E5070B-06E

S E R V I C E N O T E

E5070B ENA Series Network Analyzer, 300 kHz to 3 GHz

Change the RF signal path configuration and update firmware to 5.02 or later to improve the input damage level tolerance

Figure 15 Front View (Semirigid Cables Opt. 414 before modification)

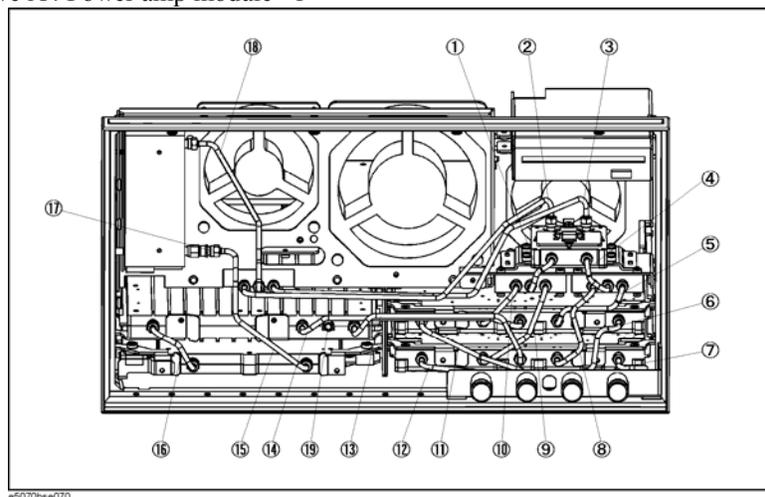
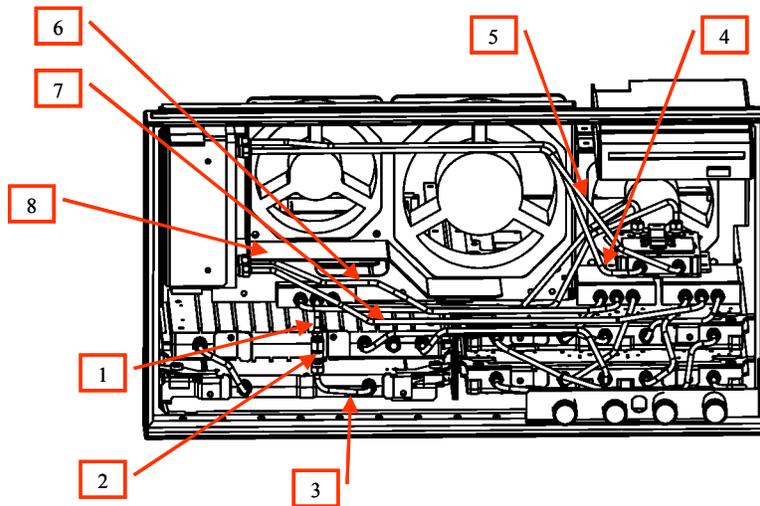
1. Remove outer cover. *1
2. Remove front panel. *1
3. Remove floppy disk drive unit. *1
4. Remove E5070-01222 (No. 8 in Figure 5) plate by 3 screws (No.9 in Figure 5)
5. Remove E5070-61685 (No 1 and No 4 in Figure 15) semi-rigid cables from A4 and A8
6. Remove E5070-61677 (No 2 in Figure 15) and E5070-61678 (No 3 in Figure 15) from A4 and A8 (source side)
7. Remove E5070-61673 (No 15 in Figure 15) semi-rigid cable from A3 and 0955-0301 (No 17 in Figure 15).
8. Remove 0955-0301 (No 17 in Figure 15) uW attenuator from A7 ATT
9. Remove E5070-61656 (No 18 in Figure 15) semi-rigid cable from A7 and A8
10. Remove defective A4 Power amp module *1

11. Remove A7 attenuator module by 2 screws (No. 7 in Figure 5).
12. Make new A7 attenuator module by 33321-60068 (2ea), E5070-61698 (2ea), E5070-61618 (1ea), 0515-0372 (2ea) and E5070-01214 (1ea). Scrap 33321-60059, E5070-01213 and E5070-61617. Refer to Figure 8 for the detail.

13. Install new A7 attenuator with 0515-0372 2 ea. Refer to Figure 9 for the detail.
14. Install new A4 power amp module to an original place
15. Connect A3 and 0955-0301 (removed in step 8) with E5070-61675 (No 3 in Figure 14, see below) semi-rigid cable

16. Connect 0955-0301 and A8 (source side) with E5070-61676 (No 1 in Figure 14)
17. Connect A8 (source side) and A4 with E5070-61677 and E5070-61678 that are removed in step 6

18. Connect A4 and A7 ATT with E5070-61633 (No 4 in Figure 14) semi-rigid cable
19. Connect A4 and A7 ATT with E5070-61635 (No 5 in Figure 14) semi-rigid cable

20. Connect ATT and A8 with E5070-61634 (No 6 in Figure 14) semi-rigid cable
21. Connect ATT and A8 with E5070-61636 (No 7 in Figure 14) semi-rigid cable

22. Screw E5070-01223 plate (No 8 in figure 14) instead of E5070-01222
23. To avoid the friction between new semi-rigid cables and front panel's cable clamp, remove two 1400-0611, cable clamp, from original place, then stick two new 1400-0611, cable clamp, as shown in Figure 11 lower. Then change a bending position of LCD flat cable (white one) according to Figure 11 upper

Copy of Figure 14 in page 16
